# Access Compliance Report

## Public Rights-of-Way

### (Curb Ramps)

Intersection ID: N/A	Main Street: NORTH_COMMUNITY_HOUSE_RD	Cross Street: COMMUNITY_COMMONS_RD	Location: SE
ADA ID: 62D1A5A733EC	Ramp Type: Directional	Initial Pass/Fail: Fail	Overall Compliance: No
Codes/Mitigation Info/Possible Solution		Field Measurements/Component Compliance	
Severity Score: 1.25

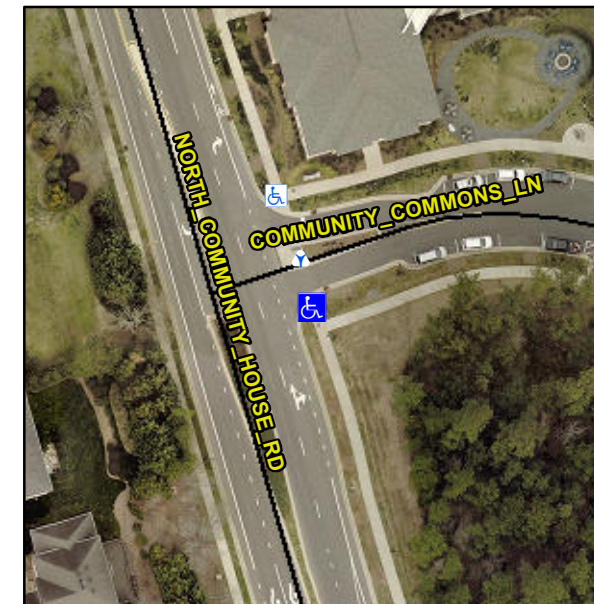
**R304.5.3**

Compliance	Description	Data	Compliance	Description	Data
N/A	Ramp Length (in)	132.0	N/A	Grade Break?	N/A
Yes	Ramp Width (in)	67.0	N/A	Grade Break Slope (%)	0.0
Yes	Ramp Slope (%)	6.4	N/A	Grade Break XSlope (%)	0.0
No	Ramp XSlope (%)	2.1			
N/A	Flare Type LT	N/A	N/A	Flare Type RT	N/A
N/A	Flare Slope LT (%)	N/A	N/A	Flare Slope RT (%)	0.0
N/A	Flare Traversable LT?	N/A	N/A	Flare Traversable RT?	N/A
N/A	Landing Length (in)	0.0	N/A	DWS Provided?	N/A
N/A	Landing Width (in)	0.0	N/A	DWS Contrast?	N/A
N/A	Landing Slope (%)	0.0	N/A	DWS Length (in)	N/A
N/A	Landing X Slope (%)	0.0	N/A	DWS Full Width?	N/A
N/A	Landing Curb? (Y/N)	N/A	N/A	DWS Offset LT (in)	N/A
N/A	Shared Landing?	N/A	N/A	DWS Offset RT (in)	N/A
N/A	Gutter Ponding?	0.0	N/A	Gutter Slope (%)	N/A
N/A	Gutter Lip Ht (in)	0.0	N/A	Gutter X Slope (%)	N/A
N/A	Painted X Walk1?	No		Road Slope (%)	1.5
	X Walk 1 Direction	To NW		Road X Slope (%)	1.3
	X Walk 1 Width (in)	N/A		Clear Space?	N/A

**Remove & Replace Entire Ramp.**
